17. COA-044893-2018

2711 East Broad Street

STAFF REPORT

Construction of a two-story secondary building.

Figure 1. Sanborn Map 1905

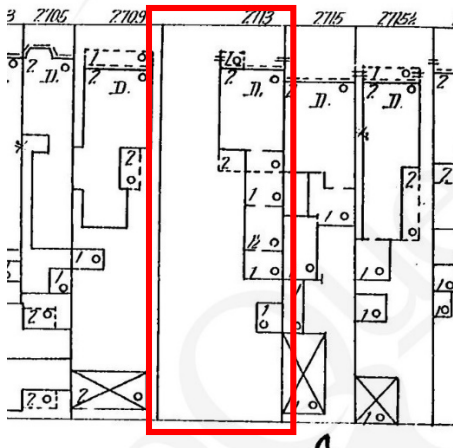
New Construction, Residential Outbuildings, pg. 51, #s1-3	<i>1. Outbuildings, including garages, sheds, gazebos and other auxiliary structures, should be compatible with the design of the primary building on the site, including roof slope and materials selection.</i>	The applicant has submitted information about the materials indicating the proposed exterior materials are compatible with the materials of the main house. The proposed gable roof is a different roof form from the shed roof found on the main house.
	<i>2. Newly constructed outbuildings such as detached garages or tool sheds should respect the siting, massing, roof profiles, materials and colors of existing outbuildings in the neighborhood.</i>	The proposed secondary building is located at the rear of property. It utilizes a roof form and materials found on other secondary resources in the district.
	<i>3. New outbuildings should be smaller than the main residence and be located to the rear and/or side of the property to emphasize that they are secondary structures.</i>	While the mass of the proposed secondary building is smaller than the primary resource, staff is concerned that it appears to be similar in height. Sanborn maps indicate the presence of a one-story outbuilding on the site, and staff recommends that the height of building be reduced. Staff also notes that either end of the alley historically had two-story secondary buildings, though the interior of block did not.
